Docket Item # 4
BAR CASE # 2008-0193

BAR Meeting
April 1, 2009

ISSUE: New Construction
APPLICANT: Sophie Development LLC
LOCATION: 714 Wythe Street
ZONE: OC/Office Commercial

Figure 8. Current submission with cornice on rear portion, side elevation.

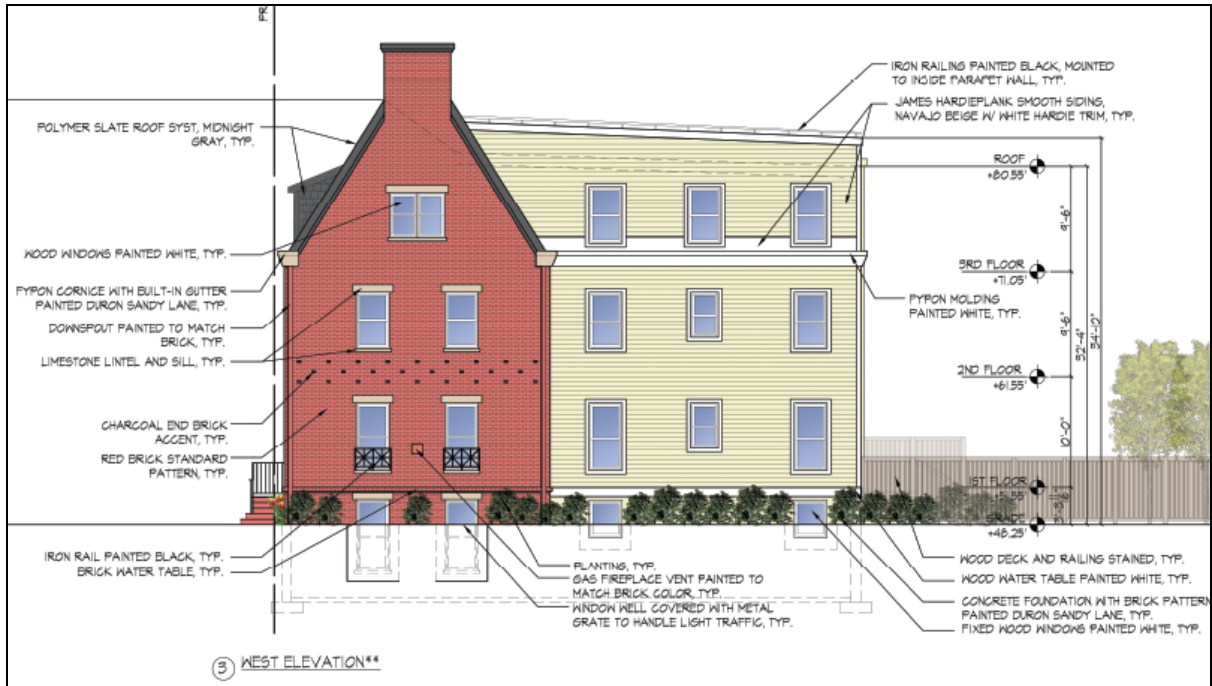
Staff finds that the latest submission is consistent with the *Design Guidelines* and the direction given by the Board at the previous hearing. Staff found the previous submission, with no differentiation in roof form, acceptable for the rear portion of the building and consistent with the *Design Guidelines*. In response to the Board's concerns, Staff has worked with the applicant and finds the revised treatment appropriate as well. The applicant prepared a study proposing a mansard roof form on the rear portion. Staff found that the mansard roof on the rear portion of a Colonial Revival style house appeared disjointed and inconsistent with the *Guidelines*. Specifically, the mixing of two very distinctive architectural styles from different time periods did not seem an appropriate treatment for minimizing the perceived height and mass of this portion of the building. In addition, the *Guidelines* advise that "the Boards favor contextual background buildings." Staff found that the higher-style roof line on the rear portion made it more visible and less of a background building. In response, the applicant prepared the alternative presented here. The pronounced cornice serves to appropriately reduce the perceived height and bulk of the addition without drawing attention to this rear portion. Staff finds that the revision is generally appropriate but recommends that the broad, flat band element intersecting with the windows be eliminated.

In summary, Staff is supportive of the current scheme with the elimination of the additional broad band trim board intersecting with the third-story windows immediately above the side and rear elevation cornice.

2. That the uppermost portion of the cornice, the broad band intersecting with the third-story windows, be eliminated.
